**Facility Response RAI SAR 4.1 items (a) and (b):**

**Facility Response RAI SAR 4.1 items (c) and (d):**

**Facility Response RAI SAR-4.2 items (a) and (b):**

Fig. 3 Calculated vs. measured axial thermal flux profiles at various locations (M-1-3).

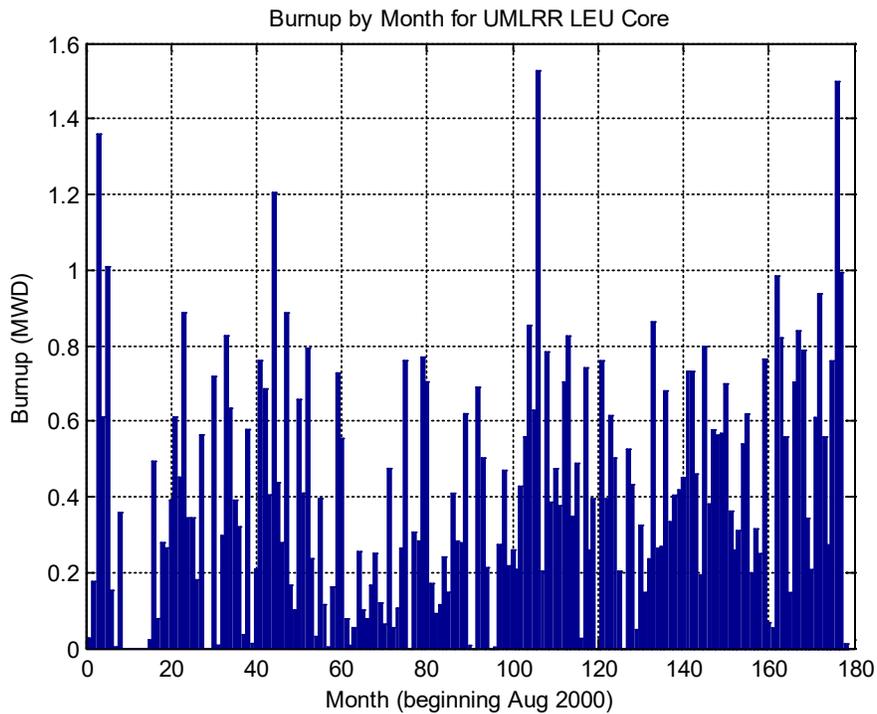
To be explicit, Tables 1 and 2 and Fig. 3 from Ref. 6 have been extracted and included here to show some VENTURE and MCNP results for a few different UMLRR core configurations. A detailed discussion of these results is given in the full reports but, as apparent from just a quick review, the models seem to do a reasonable job at predicting the base eigenvalues (with about a negative 2 - 2.5% bias for the VENTURE results), the proper blade worth distributions, and several axial flux profiles in the initial LEU startup core (M-1-3 configuration). The comparisons are reasonable considering the uncertainty inherent in the measured data (especially for the measured blade worths). The model predictions have been sufficient for routine design and analysis purposes and for preparing data for the safety analyses reported upon in the Oct. 2015 UMLRR SAR.

Updated results (from June 2015) for Figs. 3, 4, 16, and 17, respectively from Ref. 7

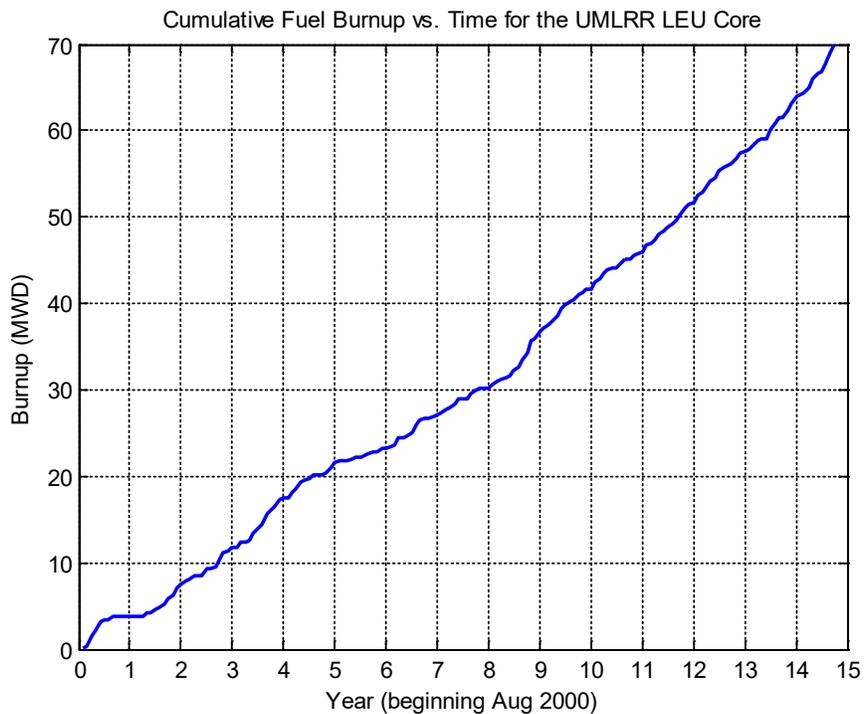
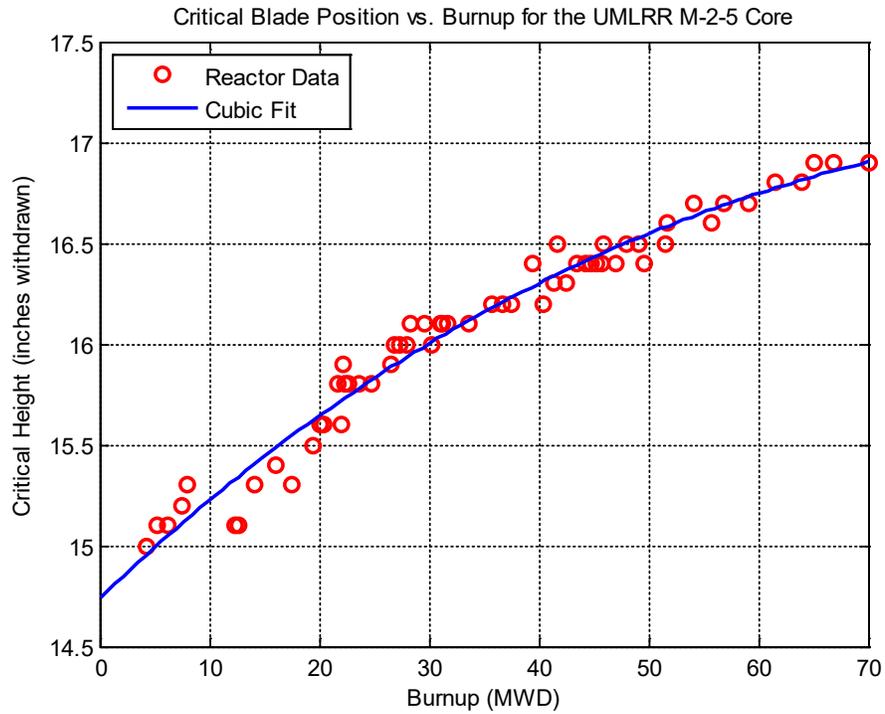
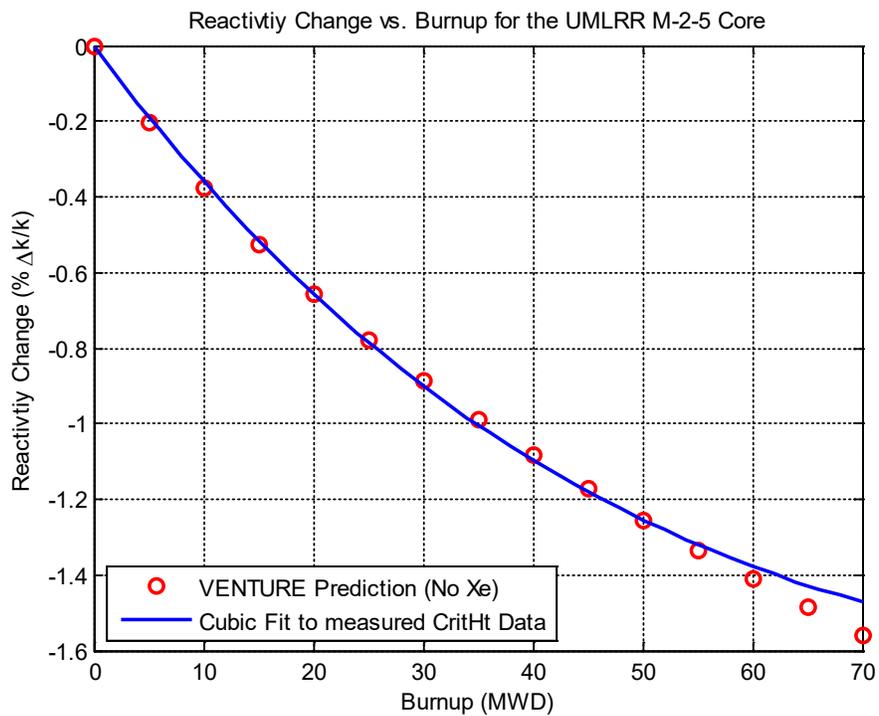
In addition, although depletion effects have not been significant for the UMLRR (due to relatively low cumulative burnup of the LEU fuel since 2000), the updated set of figures provided below (with originals from Ref. 7), show that the VENTURE depletion model provides a reasonable treatment of the fuel depletion and fission product buildup within the reactor.

**Rough sketch of the M-2-5 core configuration for the UMLRR.**

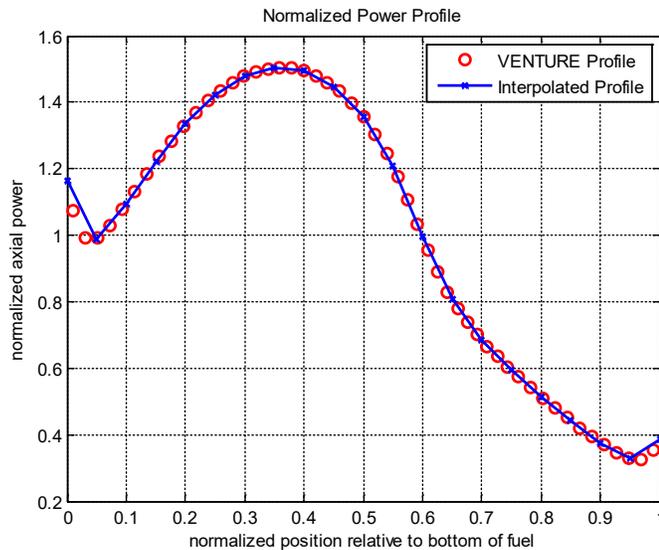
The reference core configuration for the safety analysis was chosen to be the 21-element configuration (designated M-2-5) as shown in the sketch below. This configuration includes 2 partial and 19 full  $U_3Si_2-Al$  fuel elements and it has a graphite radiation basket (GRB) in the D5 central location that was designed specifically to minimize the local power peaking in the fuel assemblies next to this element (specifically in locations D4, D6, and E5). A minimum 21-element configuration is needed for routine operation to give sufficient excess reactivity and to make sure that the regulating blade (a.k.a. regulating rod) has sufficient worth to control reactivity changes during normal operation. In addition, we know that the more severe power peaking condition is associated with the blades inserted substantially into the core. Thus, a BOL arrangement with a high excess reactivity which is made nearly critical via blade insertion often gives the desired limiting peaking factors. For the M-2-5 core, the BOL critical height was approximately 14.9 inches withdrawn, and this blade location was used in all the safety studies to be sure to maximize the computed peaking factors.

**Axial Temperature Profiles for Nominal and LSSS Conditions in Forced Flow Mode**

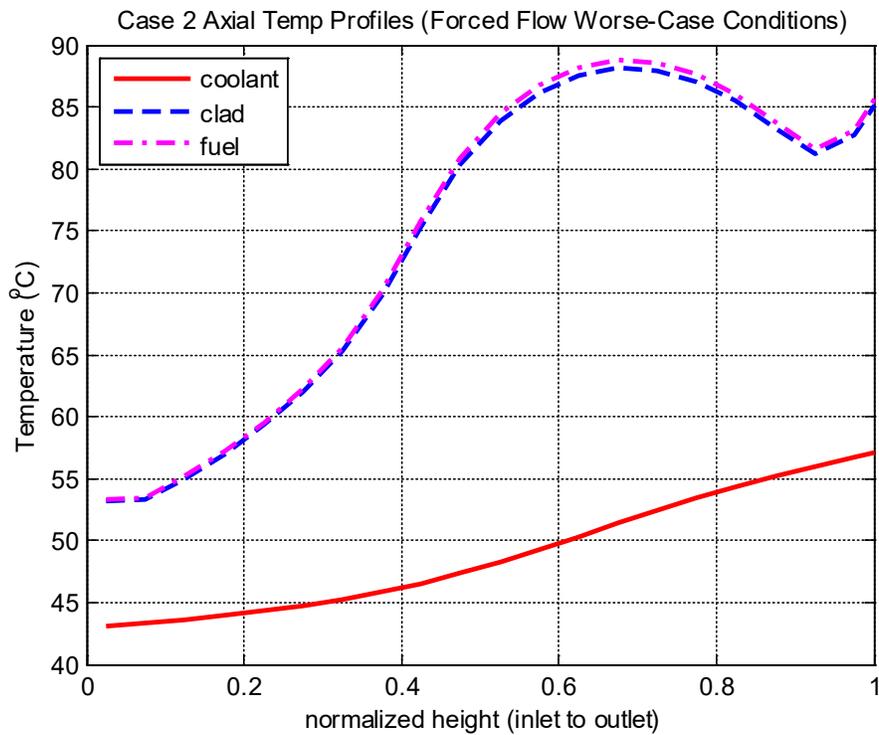
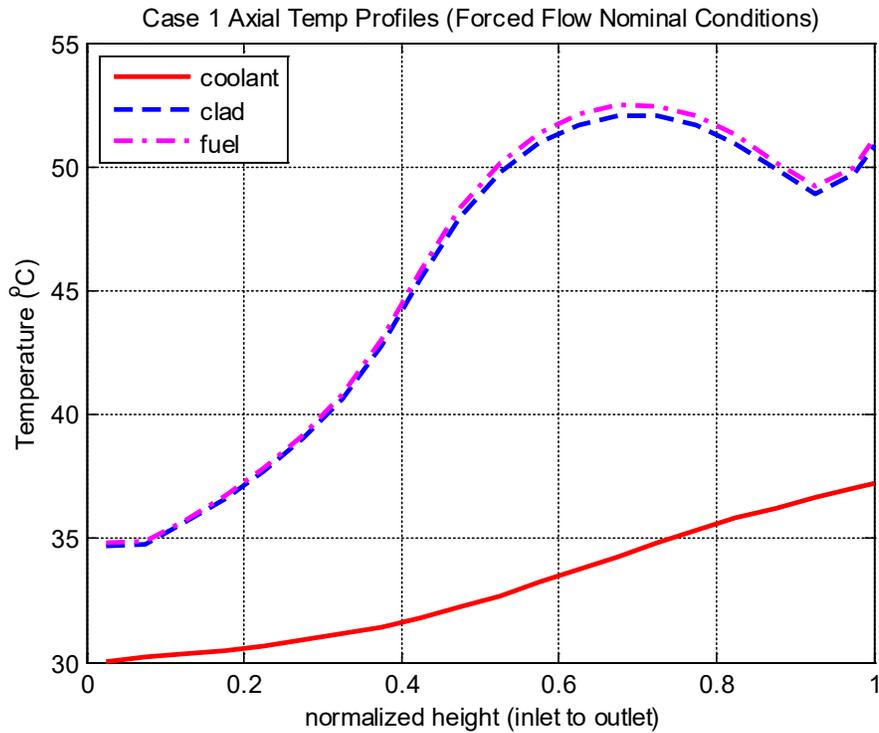
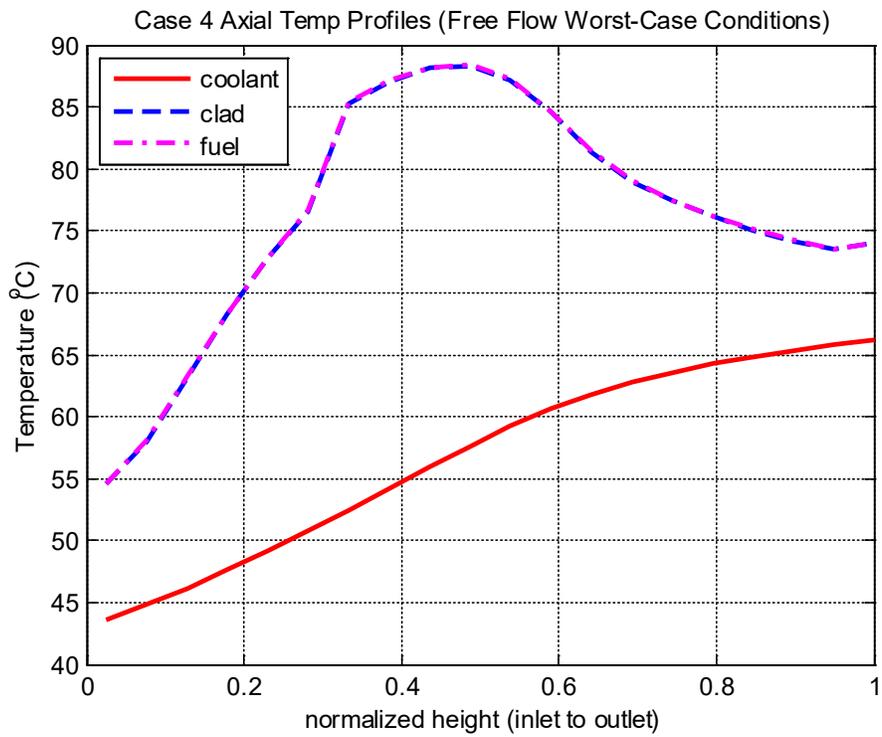
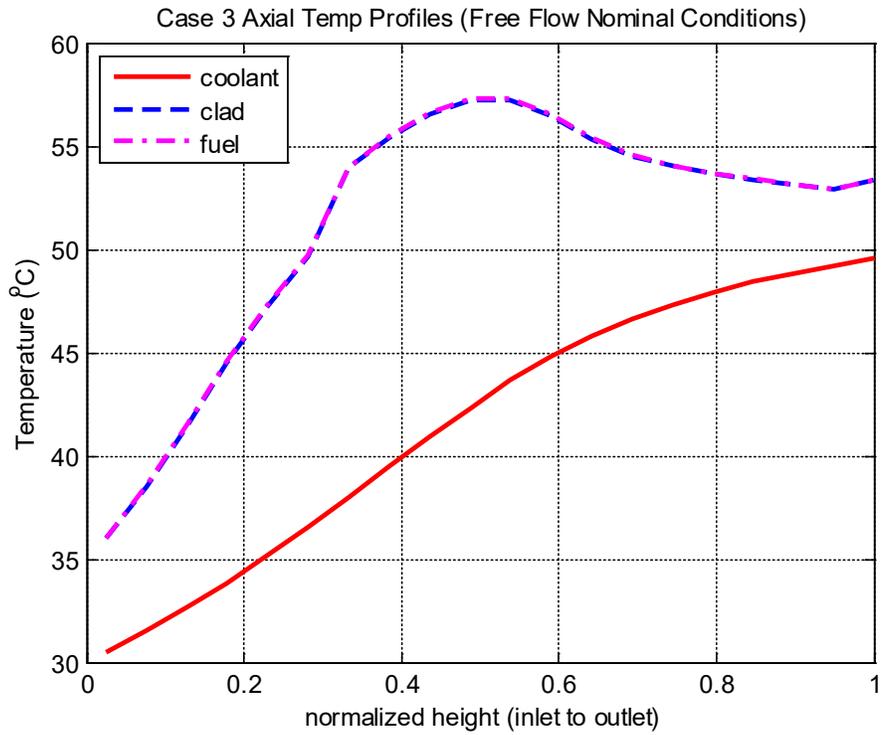
This RAI requested more comprehensive thermal hydraulic information for steady state operation of the limiting core configuration (LCC) at LSSS conditions. To address this request, we include the computed PLTEMP and NATCON fuel, clad, and coolant axial temperature profiles for the four cases noted below:

As apparent from these four cases (recall that the saturation temperature for water at about 25 psia is about 116 C), steady state operation of the UMLRR is well below the ONB point even when we assume that the LCC is at LSSS worst-case conditions.

**Comparison of transient responses (forced flow mode) for 6 mk step insertion for  $P_o = 0.01$  W (top plots) and  $P_o = 1.25$  MW (bottom plots).**

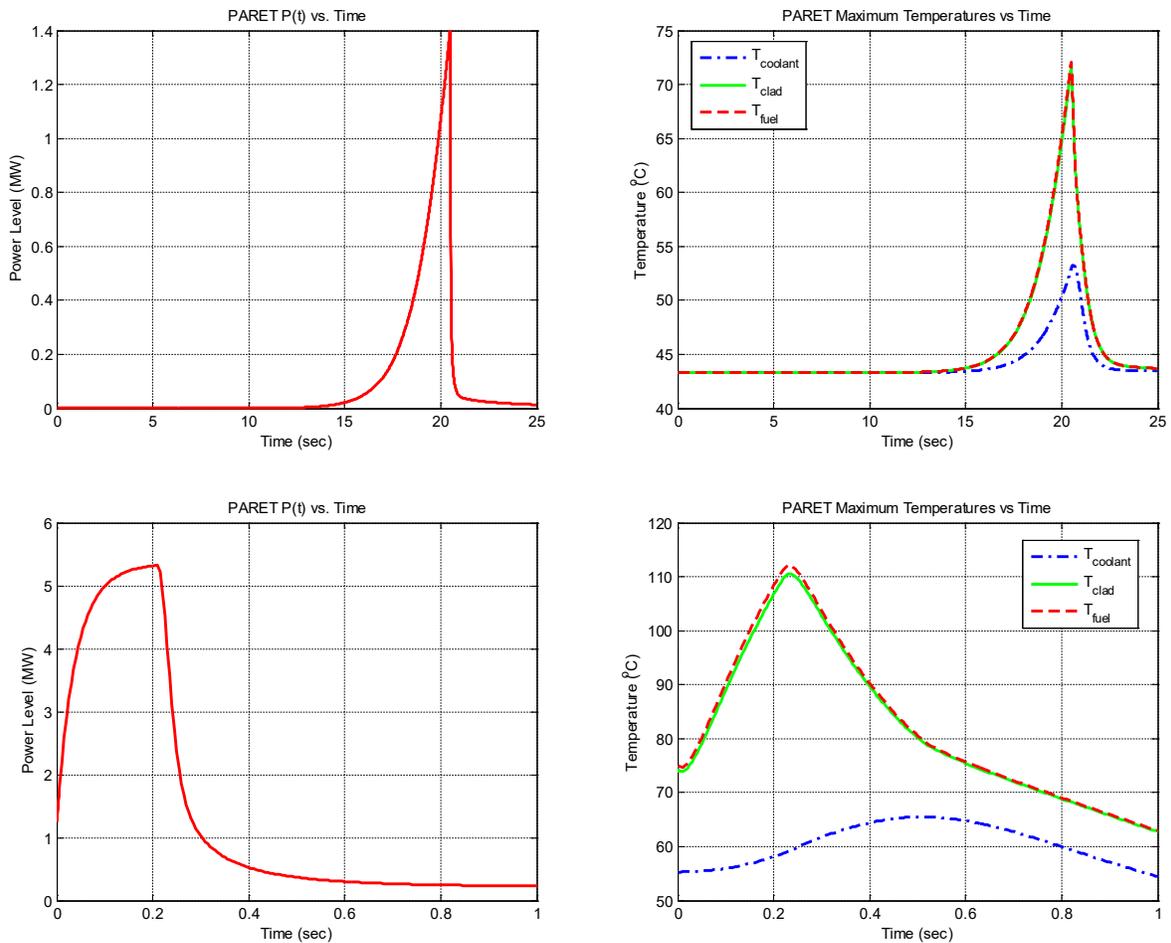
An analysis of a reactivity insertion accident during reactor startup was not performed as part of the Oct. 2015 Safety Analysis Report (SAR). This omission has been remedied and the rest of this section is focused on the description and analysis of a series of reactivity insertion events during reactor startup. In particular, it is conceivable though improbable that an off-normal reactivity transient could occur during startup due to the failure of a fixed experiment or possibly due to the rapid ejection of an experimental bayonet from one of the in-core radiation baskets, both of which can lead to a rapid reactivity insertion. In addition, operator error or a control rod drive malfunction during reactor startup could lead to a ramp insertion of reactivity while the reactor is initially at a low-power state. Both rapid (near step) and ramp reactivity insertions were analyzed and discussed as part of the Oct. 2015 UMLRR Safety Analysis Report (SAR), but none of the situations addressed started at a low power level -- all the transients were initiated at rated or LSSS power levels.

To address an inadvertent reactivity insertion during startup, a series of PARET simulations were made with an initial power level of  $P_o = 0.01$  W, including both step and ramp insertions under both forced and free flow conditions. In all cases the inlet temperature was at the LSSS value of 43.3 °C and, for the forced flow cases, the core flow rate was also at the LSSS value of 1370 gpm (this gives a mass flux of 799.1 kg/s-m<sup>2</sup> down through the core). For the natural convection cases, the initial mass flux was set at 0.001 kg/s-m<sup>2</sup> up through the core since PARET will not execute properly with an initial flow rate set to exactly zero. In all cases, it was assumed that the transient was terminated by the over-power trip signal (1.25 MW for forced flow and 0.125 MW for the natural convection cases) with a 210 msec instrument delay time between when the trip level is exceeded and the blades begin to drop. Though not required by NUREG 1537, this scenario assumes the short period trip is inoperable and not included within any of the simulations.

In particular, for the  $\Delta\rho = 6$  mk step insertion cases, when  $P_o = 0.01$  W, the power levels and temperatures spike about 15-20 seconds after the transient is initiated. In contrast, when  $P_o$  is the LSSS power level, the transient is essentially over in under 1 second, since the over-power trip is initiated immediately and after about 0.21 seconds due to the instrument delay, the control blades start to drop, terminating the transient. However, as apparent in the comparison plots, the cases with  $P_o$  at the LSSS level are more limiting since the peak transient power level and the peak temperatures for both the forced and natural convection simulations are much larger than for the corresponding simulations involving a reactor startup scenario (with  $P_o = 0.01$  W). The most important observation, however, is that none of the 6 mk step insertion simulations reached the ONB limit for the UMLRR. It is clear an experiment malfunction that rapidly inserts a maximum of 5 mk of reactivity will not exceed the ONB limit, independent of the initial power level of the system.

**Comparison of transient responses (forced flow mode) for 0.7 mk/s ramp insertion for  $P_0 = 0.01$  W (top plots) and  $P_0 = 1.25$  MW (bottom plots).**

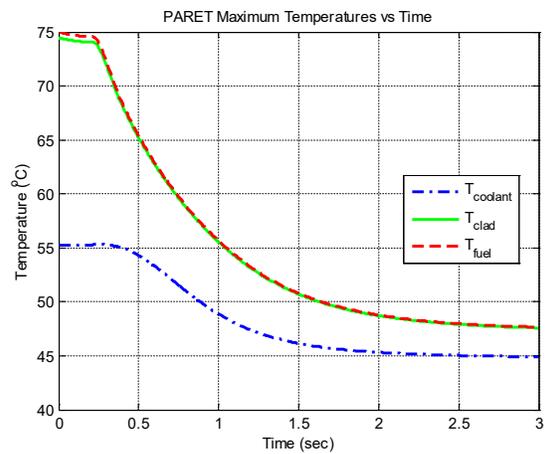
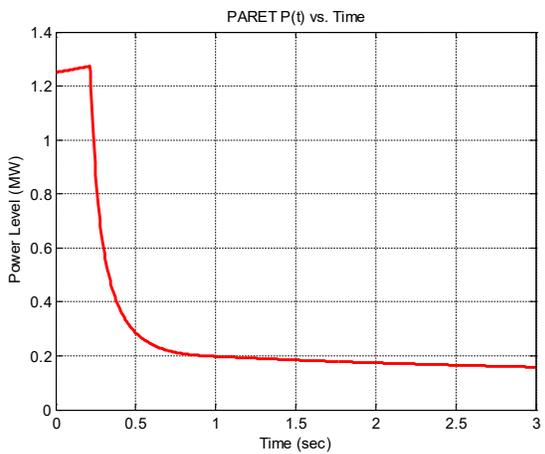
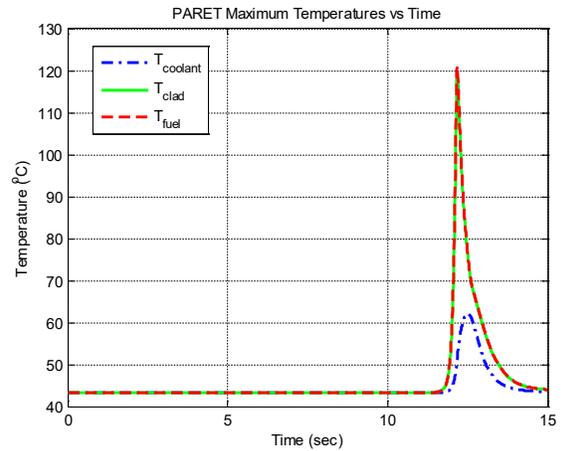
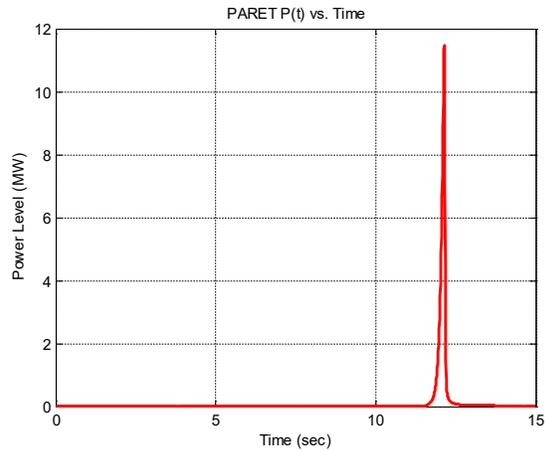
For the ramp insertion cases, the initial conditions are similar, but the results are quite different. For the startup scenarios with  $P_0 = 0.01$  W, the powers and temperatures have very sharp spikes about 12 seconds into the transient and, as above, the transient has essentially terminated within 1 second for the cases where  $P_0$  is at the LSSS level. However, the key difference here is that the ramp reactivity insertion continues for a relatively long time (about 12 seconds) for the reactor startup simulations, and this can lead to a large total reactivity insertion level before the transient is terminated by the over-power trip signal. In fact, a 0.7 mk/s insertion rate over 12 seconds gives  $\Delta\rho = 0.0084 \Delta k/k$ , which is over 1\$ of positive reactivity for the UMLRR. This creates the very fast power and temperature spikes that are observed for the reactor startup cases. As seen in the comparison plots, the rapid spikes for the startup simulations make these cases more limiting than the corresponding scenarios when  $P_0$  is at the LSSS power level.

However, as before, the most important observation is that none of the 0.7 mk/s ramp insertion simulations reached the ONB limit for the UMLRR. The forced convection case was closest with a peak clad temperature of just under 120 °C. Nevertheless, these simulations indicate that an accident during startup that leads to a ramp reactivity insertion rate of 0.5 mk/s (the TS limit) will not exceed the ONB limit set for the UMLRR safety analyses.

Figure 13.2.1

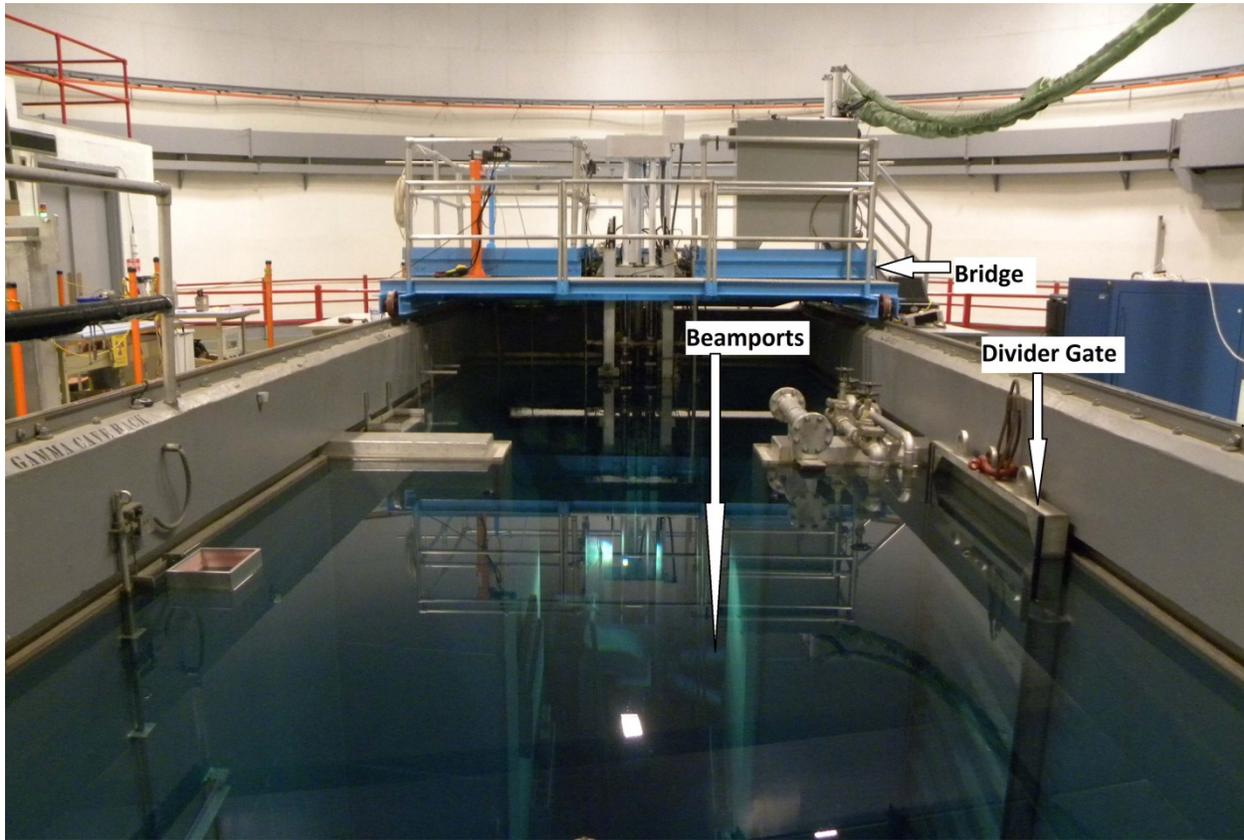
It is highly unlikely that the beam-ports could be severely damaged by a falling object while the reactor core is in the stall pool due to the restricted space and protection afforded by the reactor bridge (SAR Section 4.2.5). The reactor bridge spans the entire width of the reactor pool and provides support of the reactor core and the core suspension frame, as well as serving as an access platform (Figure 13.2.1). The bridge consists of two separate sections of structural frame work set horizontally one above the other and supported on each side of the pool by a two-wheel, rail-mounted truck assembly. The truck assembly allows the reactor bridge to be positioned at any desired location within the reactor pool. When positioned in the stall pool, the bridge provides for direct vertical protection of the beam-ports (Figure 13.2.1).

An additional and important safety feature is the pool divider gate (Figure 13.2.1) that allows separation of the stall pool from the bulk irradiation pool. The pool divider gate is constructed of reinforced aluminum and is approximately 5 ½ feet wide by 27 feet high. A rubber gasket located around the edges of the gate provides a watertight seal. The gate permits independent drainage of either pool section for maintenance purposes. Similarly, a severe leak in one side of the pool can be prevented from uncovering the core by moving the reactor to the unaffected side
